# THE NETWORK BUILDING

WHITFIELD STREET ELEVATION

## **Whitfield Street Summary**

## WHITFIELD STREET FRONTAGE - AMENDMENTS

Whitfield Street Facade Section  
(As presented to Camden, November 2022)

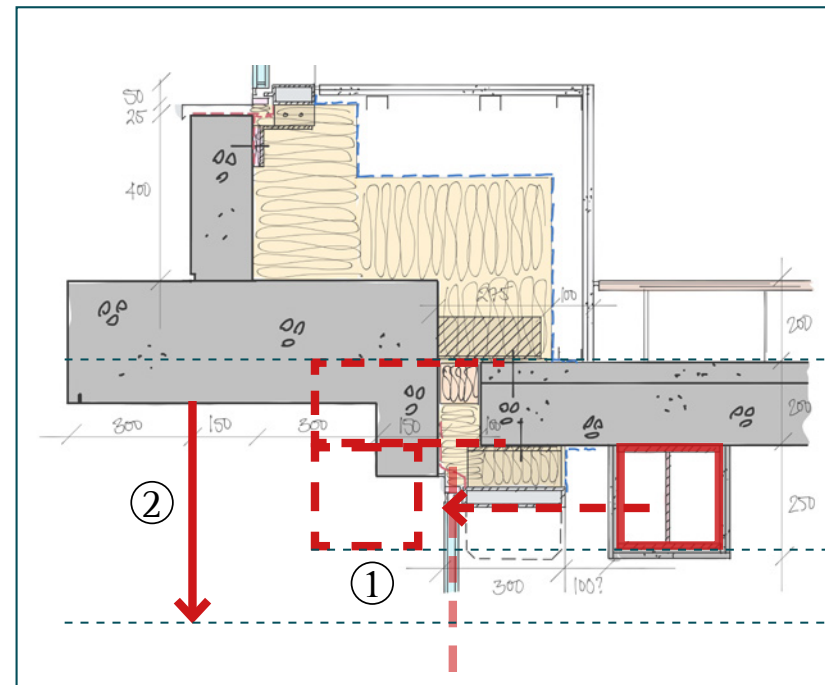
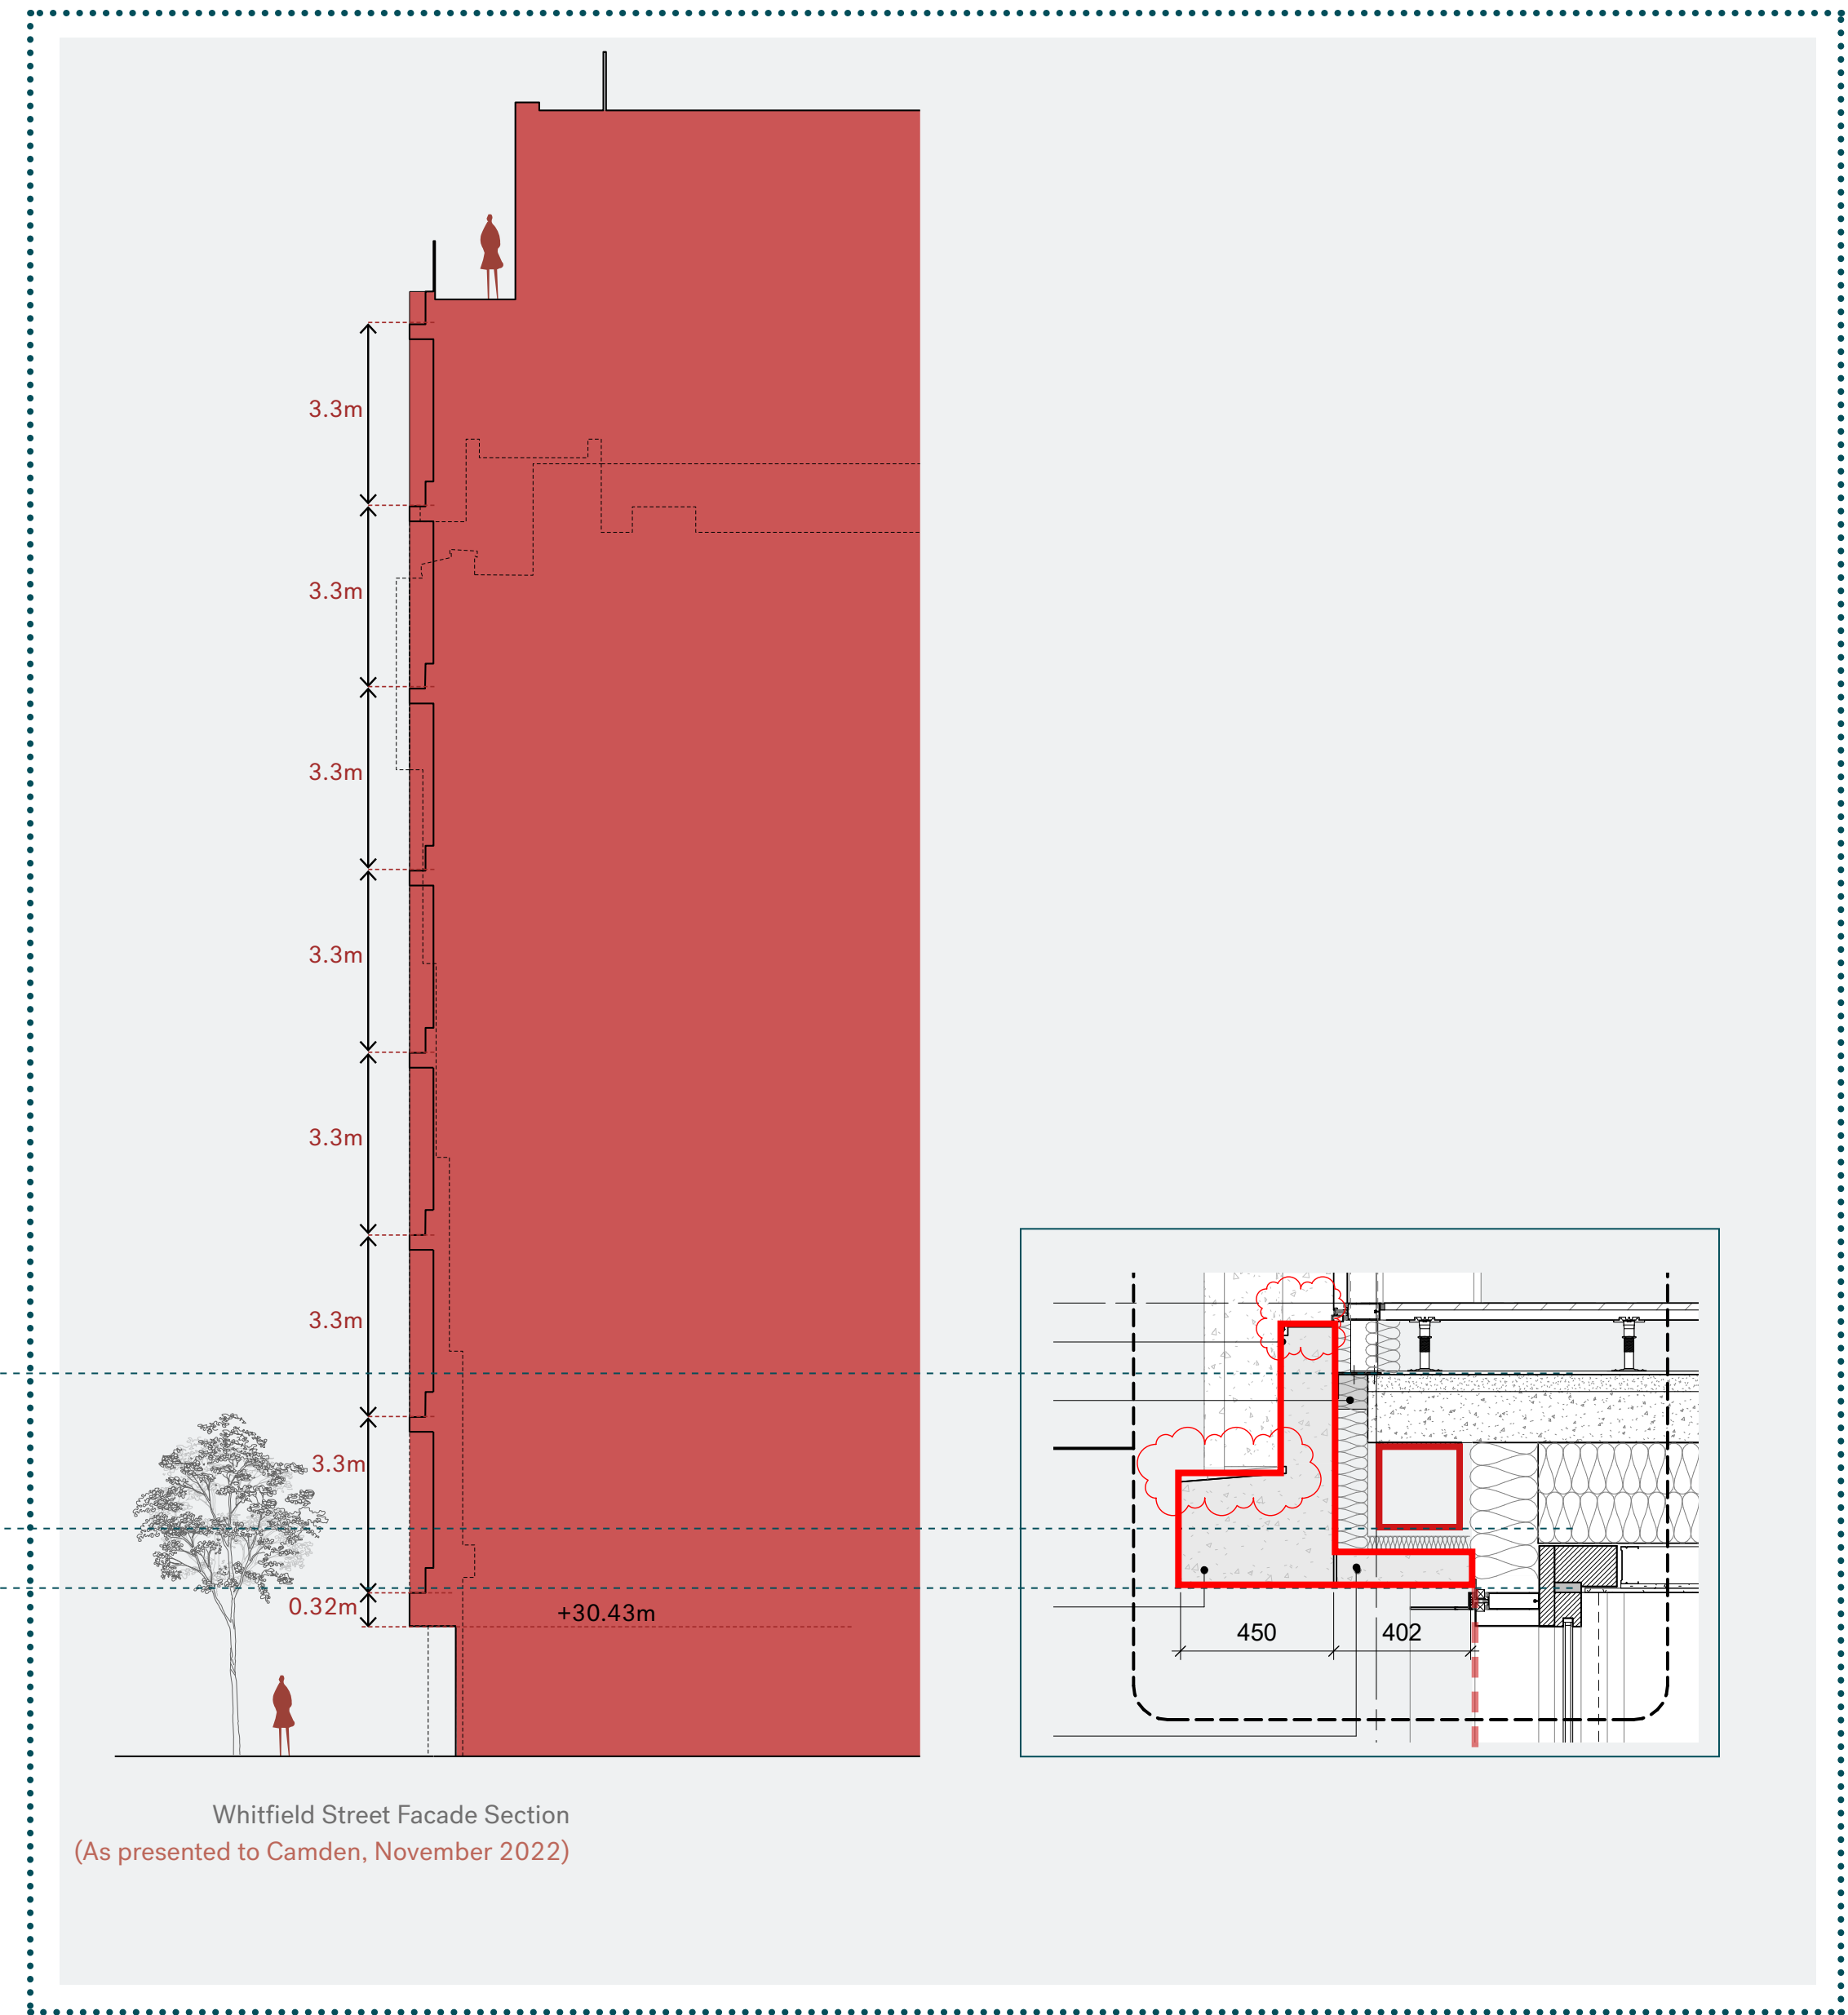
The sill profile above Whitfield Street bike entrance has been dropped by 500mm to resolve a clash between the structure and the facade. This results in a well proportioned precast panel that matches the panels above at Level 01 in line with a typical precast donut bay.

The adjacent details illustrate the structural implications of the facade set back at ground floor, which was agreed with Camden at planning.

To accommodate the cantilever, the precast soffit panel and sill profile must sit below the edge beam, as shown on the detail on the right hand side.

- ① Structurally, to be able to support the cantilevering facade, the slab and the edge beam had to shift to the edge of the facade line.
- ② Consequently, the curtain walling has to sit beneath the edge beam and the soffit dropped to align with the top of the glass.

Whitfield street Ground Floor Frontage ~ November 2022

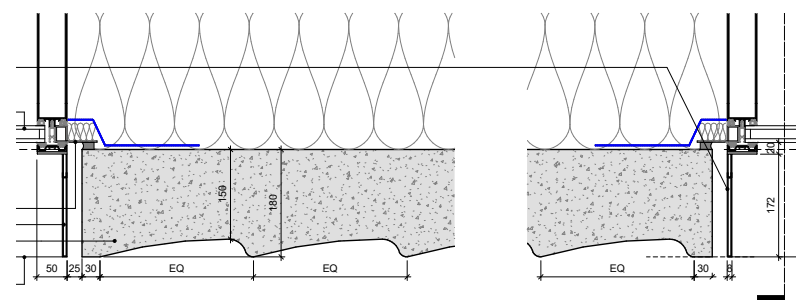
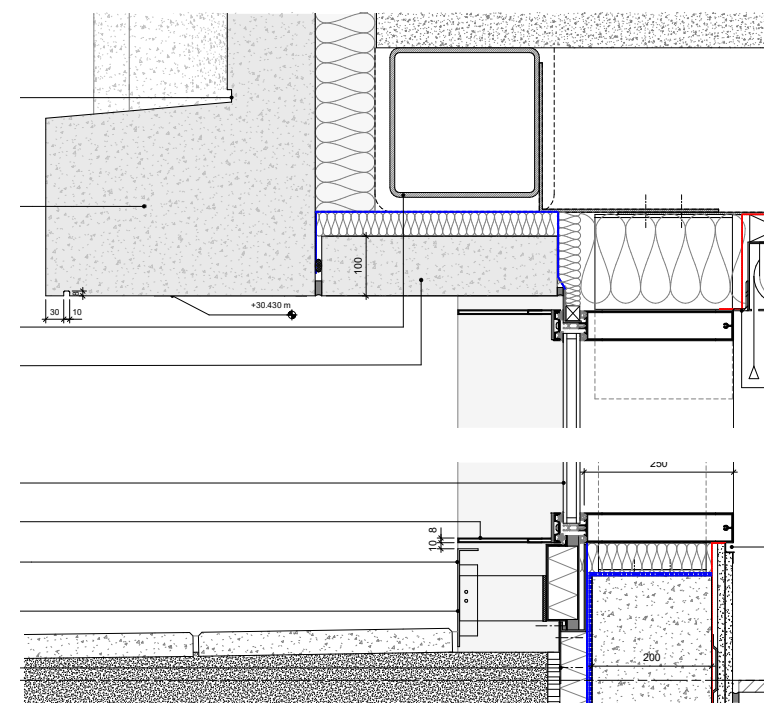
The developed proposal introduces precast piers that align with the lighter precast above when viewed in elevation, whereas previously these aligned every second pier.

Instead of replicating the profile of the panels above, the new panels include a smaller repeating version of the curve which helps with the verticality and the proportion of the panels.

Panels highlighted in red have been introduced instead of glazed panels

Whitfield street Ground Floor Frontage - Current Design

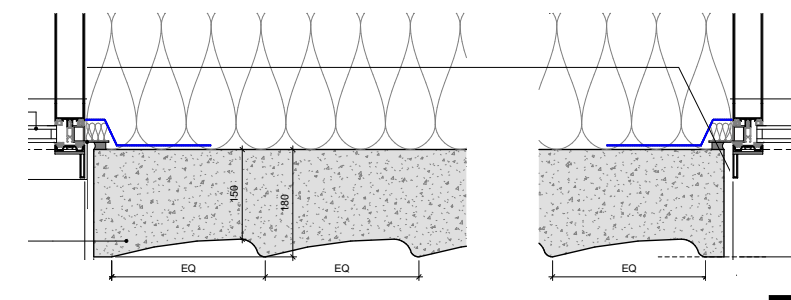
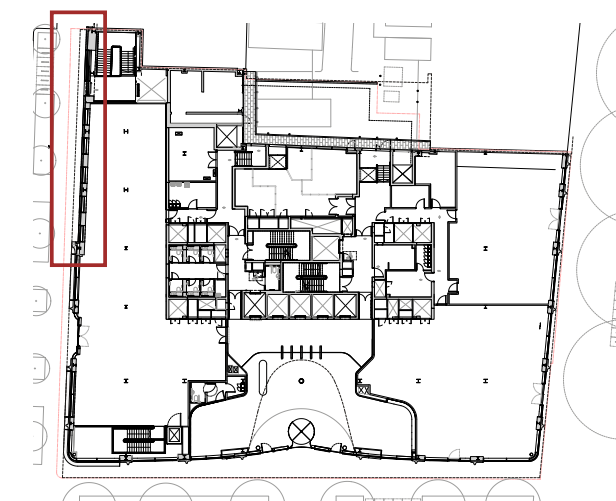
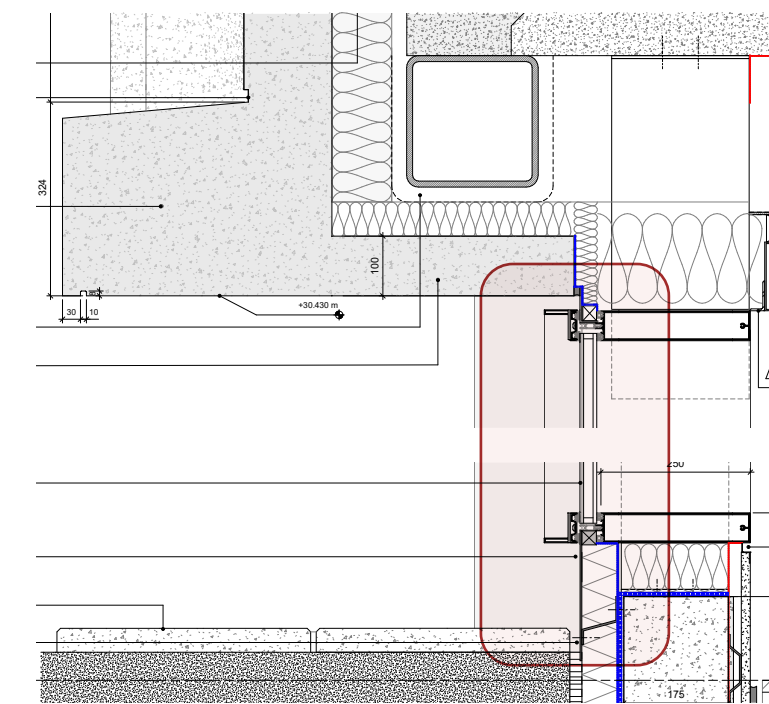
Condition 2 drawing shows 4 'waves' per profile however the final panel design is as shown in November 2022 with 5 'waves'

Depth of Curtain walling caps reduced

Sill depth reduced
